Case Studies Prepared In Conjunction  
With A Report To The  
Government Activities Subcommittee,  
Committee On Government Operations,  
House Of Representatives, On Need  
For Improved Controls For Identifying  
And Correcting Safety Defects  
On Light Aircraft B-164497(1)

**BY THE COMPTROLLER GENERAL  
OF THE UNITED STATES**

JUNE 15, 1973

**ILLUSTRATION OF FUEL INTERRUPTION  
DURING SLIP MANEUVER**

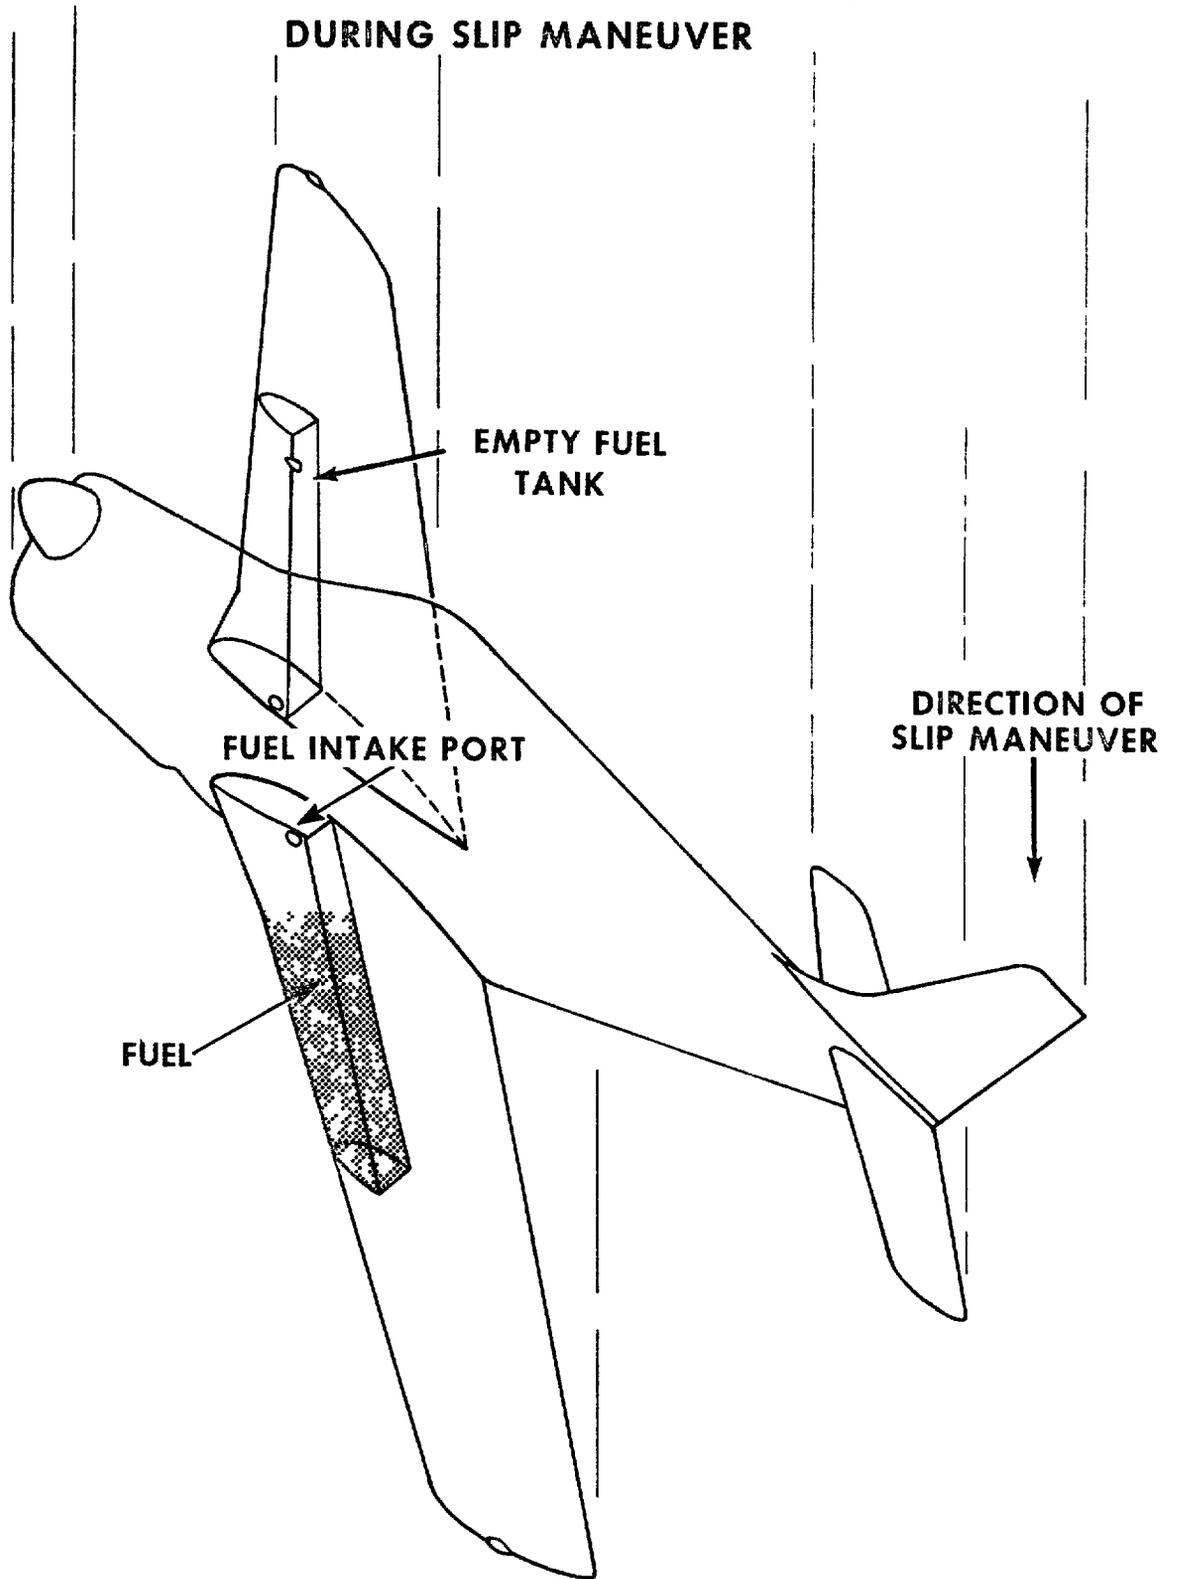
"When making a rolling takeoff when the tanks register half full, the centrifugal force throws the gas to the outside of the tanks and the engine quits dead after the airplane is airborne  
\* \* \* [a sales representative] tried this several times and found it to happen each and every time that he experimented with the rolling takeoff "

Shortly thereafter Beech initiated a design program to develop a fuel tank baffle<sup>1</sup> that would retain fuel over tank intake ports during taxi and abrupt flight maneuvers. In November 1961 Beech decided to dispense with its design program because efforts to develop an effective modification had been unsuccessful.

Beech determined that, in lieu of the baffles, warnings to owners of the Bonanza and Debonair aircraft would be sufficient to rectify the potential safety hazard. Beech issued a service letter in December 1961, advising owners of the condition and stating that it did not constitute a hazard but could be disconcerting. Beech officials stated that the rate of fuel interruption incidents, compared to the number of aircraft in service, was such that it did not appear necessary to implement design changes.

**ILLUSTRATION OF FUEL INTERRUPTION DURING DEEP DESCENTS**

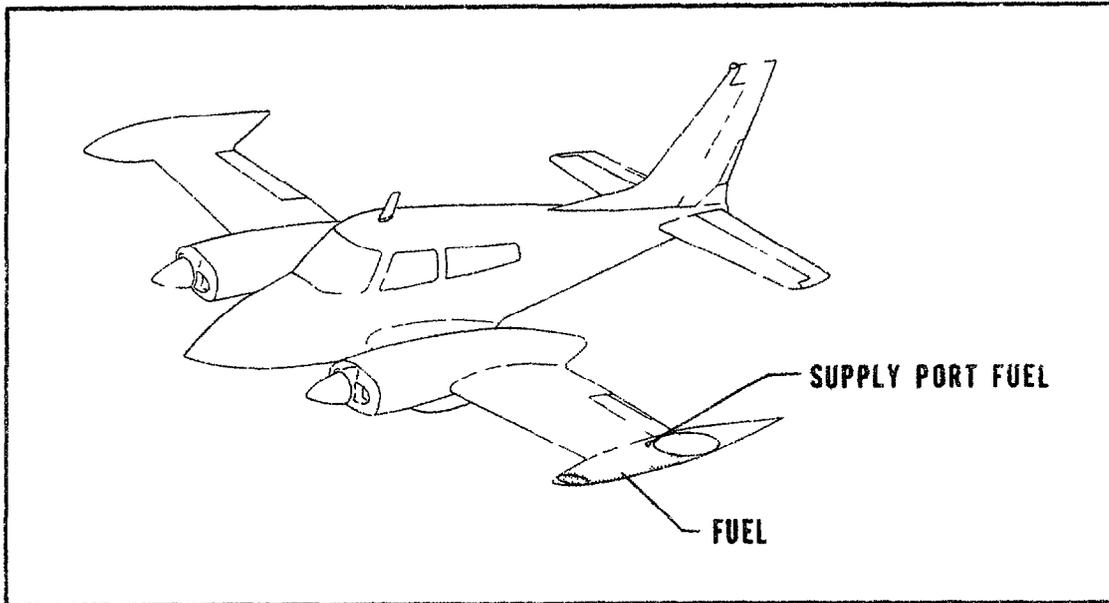
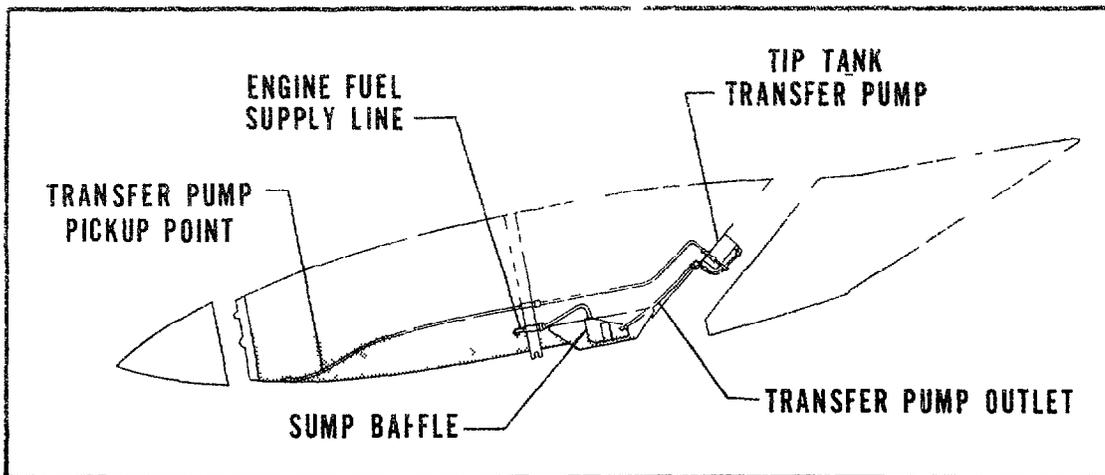
FAA conducted flight tests of an aircraft of the same type in April 1969. FAA advised Cessna on May 15, 1969, that its tests were conducted as prescribed in Cessna's Owner's Manual and that they showed that an engine or engines would quit during the test descent with up to 5 gallons of fuel remaining. Therefore FAA advised Cessna that it considered engine stoppage due to fuel starvation at the recommended approach speeds and configurations an unsafe condition that could occur under normal flight conditions and that immediate corrective action was needed. FAA told Cessna that, until more suitable action could be taken, an airworthiness directive would be issued to require placards prohibiting flight with less than 10 gallons of fuel in the main tank. On the basis of its tests, Cessna considered that encounters with

fuel difficulties were of an inconsistent nature and occurred in aircraft operations, such as prolonged power off steep descents, which Cessna considered abnormal

After further tests and discussions, FAA issued an airworthiness directive dated June 4, 1969, requiring that owners of post-1962 models of Cessna 300 and 400 aircraft (most of the operating fleet) install placards reading "Operation with less than 10 gallons of fuel in each main tank is prohibited "

On June 27, 1969, Cessna advised owners about certain Cessna-developed modifications to the fuel system that would allow the safe operation of the aircraft without the restrictions imposed by FAA's directive (See illustrations on p 32 ) The modifications were acceptable to FAA On June 30, 1969, FAA amended the airworthiness directive of June 4, 1969, to exempt those aircraft which had been modified The owners of the unmodified aircraft were required to have them modified on or before January 1, 1970, in accordance with Cessna's service letter of June 27, 1969, or by an equivalent method approved by FAA Cessna officials stated that, at a cost of over \$500,000, they provided the required parts and labor to make the modifications on affected aircraft

**ILLUSTRATION OF AIR FLOW MODIFICATION KIT  
INSTALLED TO IMPROVE HANDLING CHARACTERISTICS**

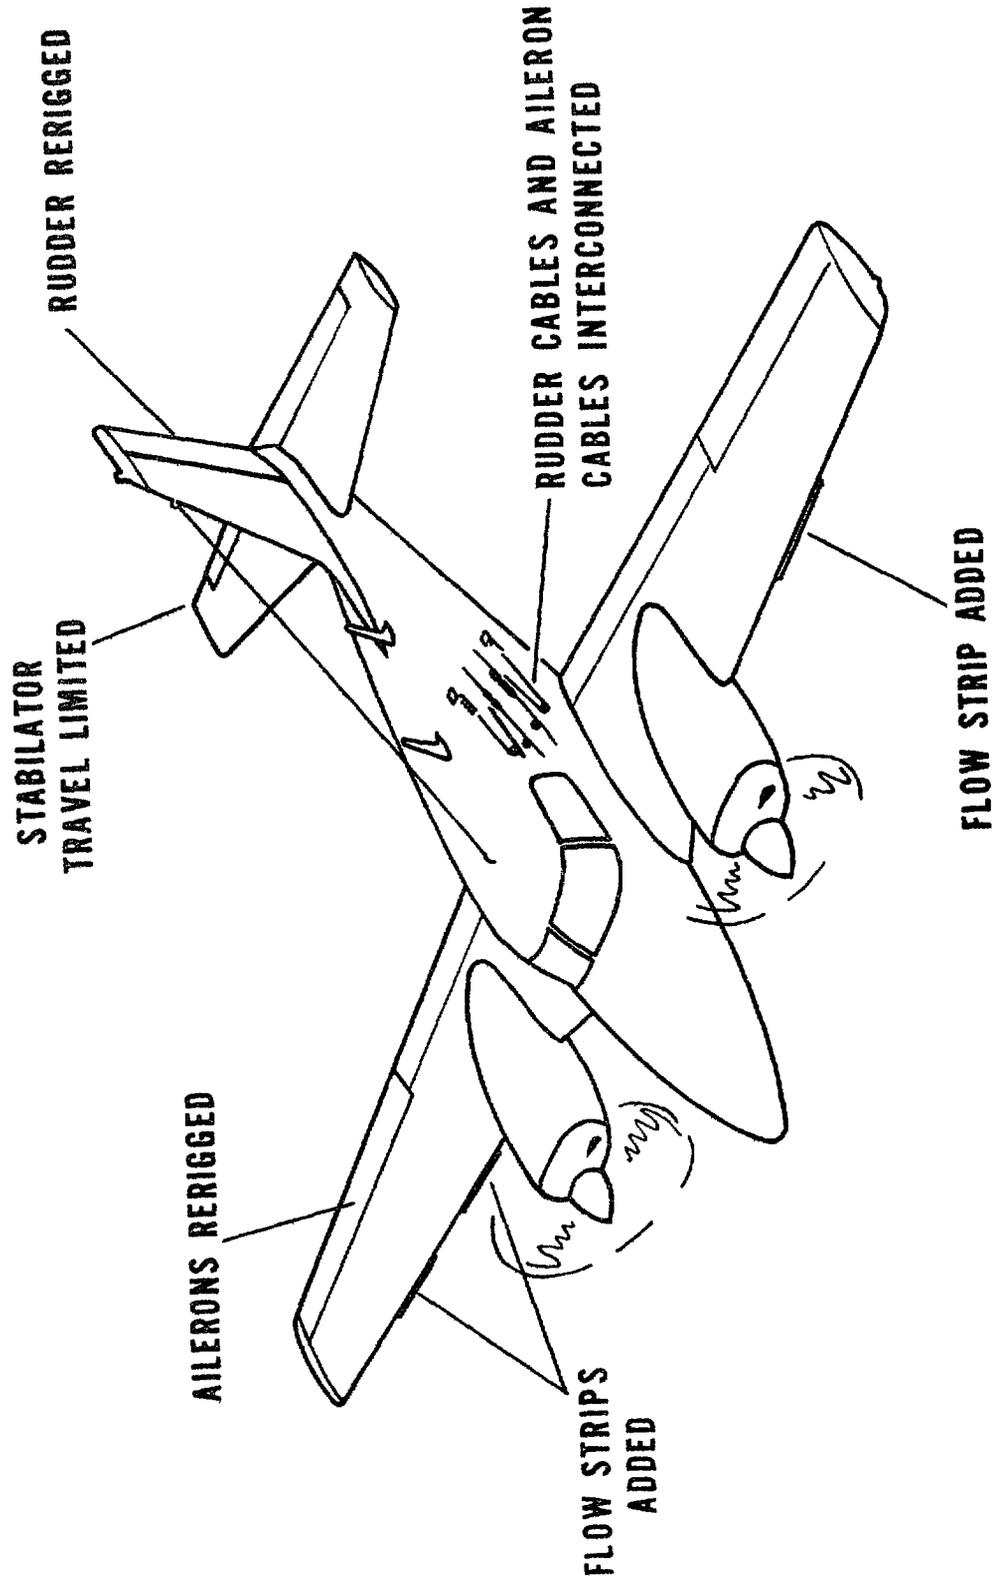
In a meeting with FAA on April 29, 1970, Piper proposed improving the Piper 30 flight characteristics during slow-speed maneuvers by installing airflow modification kits on the aircraft. At the meeting the Deputy Director of the Flight Standards Service furnished the eastern region with guidelines for evaluating the Piper 30 modification program. The guidelines provided that (1) the project not be a team evaluation, (2) the test for lateral stability be handled on a comparative basis to insure the modification provides an aircraft comparable to or better than the basic Piper 30, and (3) the test for stall characteristics use exceptional pilot skill. FAA justified using exceptional pilot skill as a criterion to obtain results comparable with the 1964 tests.

In May 1970 the eastern region flight-tested a Piper 30 on which Piper had installed an airflow modification kit. Piper further modified the Piper 30, and on June 2, 1970, the eastern region retested the aircraft and found it complied with FAA regulations. The modifications included airflow strips installed on wing leading edges, the aileron-rudder interconnect, and other changes illustrated on page 51.

**ILLUSTRATION OF FIRE-EXPLOSION  
HAZARD FROM FUEL CELL LEAKAGE**

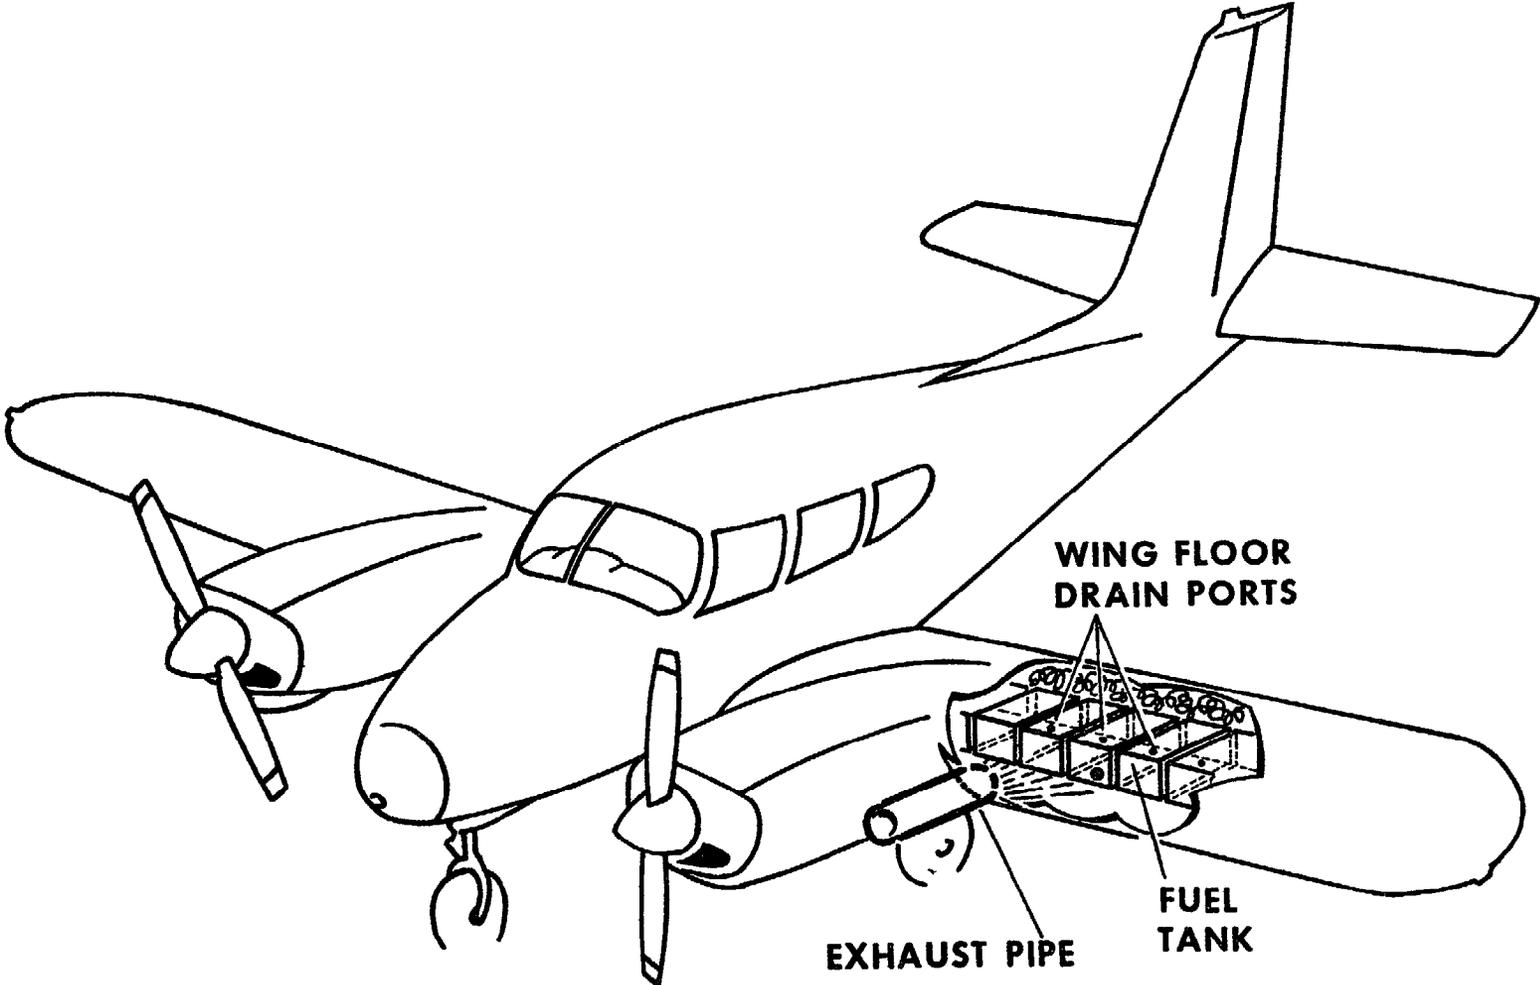
As the result of an April 1967 report indicating that a fire had occurred around the fuel tank of a Piper 23-250,

Because of continuing incidents, FAA requested Piper to reevaluate the problem to determine corrective actions and suggested that design changes to the drainage, ventilation, or exhaust systems might be required. FAA issued an airworthiness directive in February 1970 and revised it in May to require inspections of the lower wing surfaces for evidence of fuel leakage or stains. If such evidence was found, corrective actions or repairs were required. Piper

Piper established a design modification in November 1971 to eliminate the hazard principally by making the wing drain holes smaller. This modification was incorporated on Piper 23-250 aircraft produced starting about February 1972. The Piper 23-235 aircraft were no longer in production. At the time of the modification, 3,270 Piper 23-250 aircraft and 118 Piper 23-235 aircraft had been produced. FAA did not make the modification mandatory for these aircraft but authorized discontinuing certain periodic inspections on those inservice aircraft which had been modified. Information as to how many of these aircraft had been modified was not available.
